PLANNING CLEARANCE
(Single Family Residential and Accessory Structures)
Grand Junction Community Development Department

BLDG ADDRESS 370 Plateau TAX SCHEDULE NO. 2945-201-09-040
 SUBDIVISION Ridges SQ. FT. OF PROPOSED BLDG(S)/ADDITION 1450
 FILING 3 BLK 17 LOT 12B SQ. FT. OF EXISTING BLDG(S) N/A
 (1) OWNER Alan C. Rogers NO. OF DWELLING UNITS
 BEFORE: 0 AFTER: 1 THIS CONSTRUCTION
 (1) ADDRESS 2086 Hodessa Ct.
 (1) TELEPHONE (303) 256-0119 NO. OF BLDGS ON PARCEL
 BEFORE: 0 AFTER: 1 THIS CONSTRUCTION
 (2) APPLICANT Same USE OF EXISTING BLDGS N/A
 (2) ADDRESS _____ DESCRIPTION OF WORK AND INTENDED USE: _____
 (2) TELEPHONE _____ Private Residence S/F

► APPROVAL FOR BUILDING PERMIT ◄
Ridges Architectural Control Committee (ACCO)

LOT 12B
BLOCK 17
370 PLATEAU DRIVE

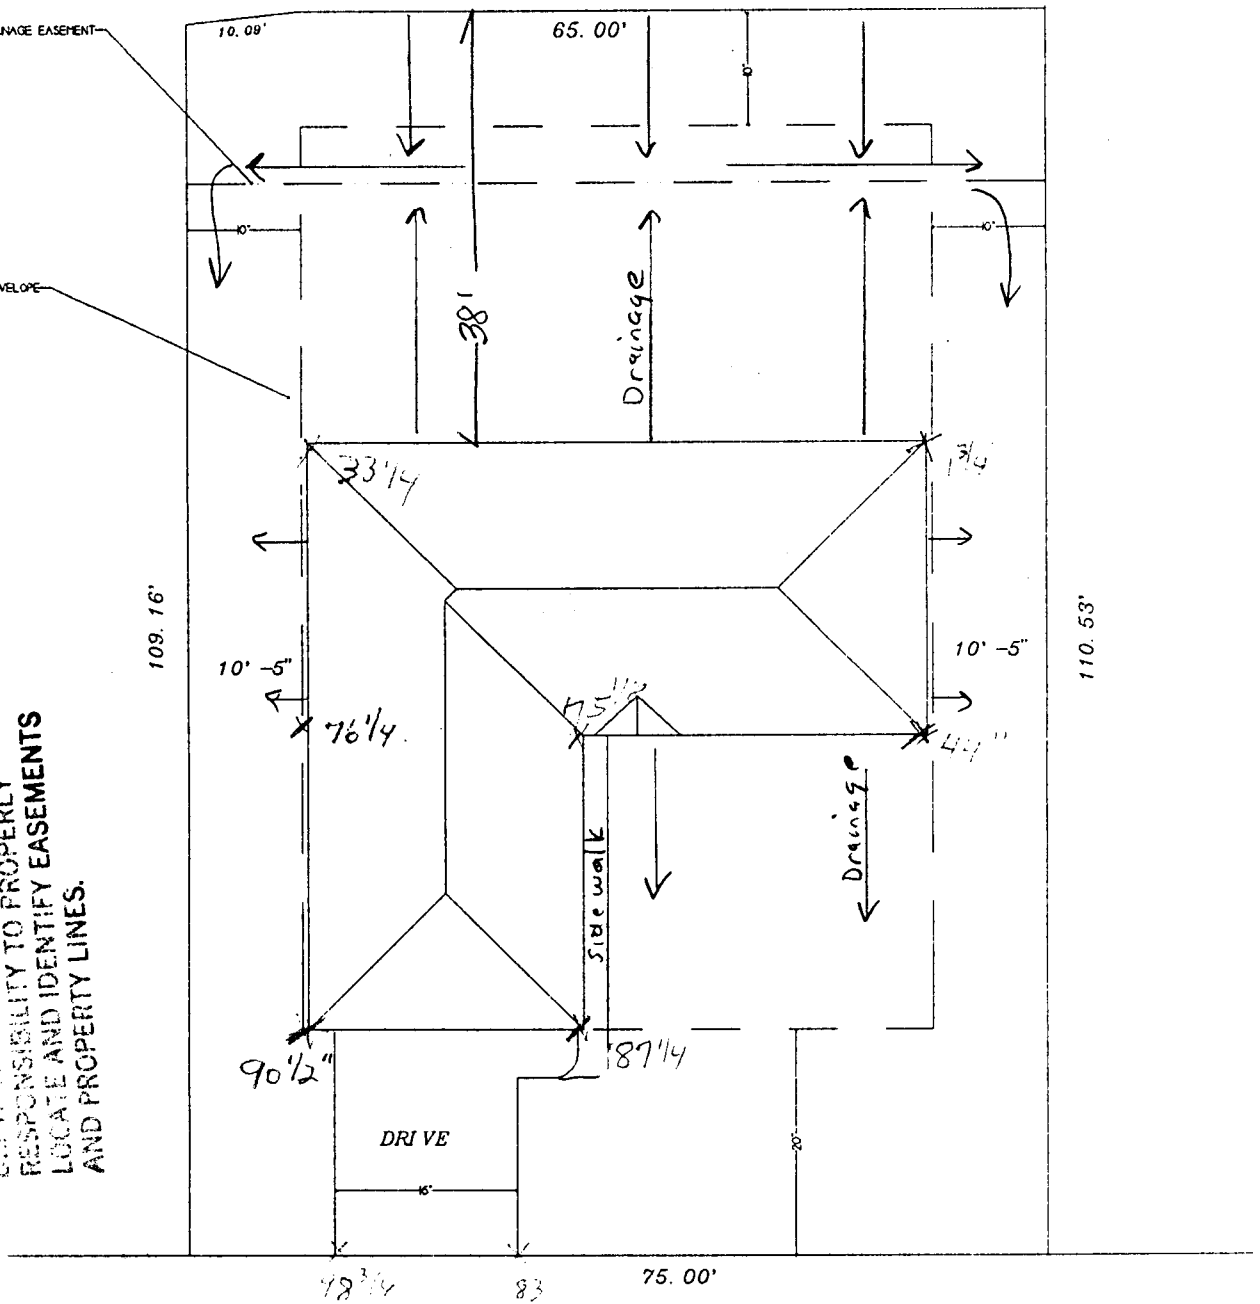
ACCEPTED 12/16/94
ANY CHANGE OF SETBACKS MUST BE
APPROVED BY THE CITY PLANNING
DEPT. IT IS THE APPLICANT'S
RESPONSIBILITY TO PROPERLY
LOCATE AND IDENTIFY EASEMENTS
AND PROPERTY LINES.
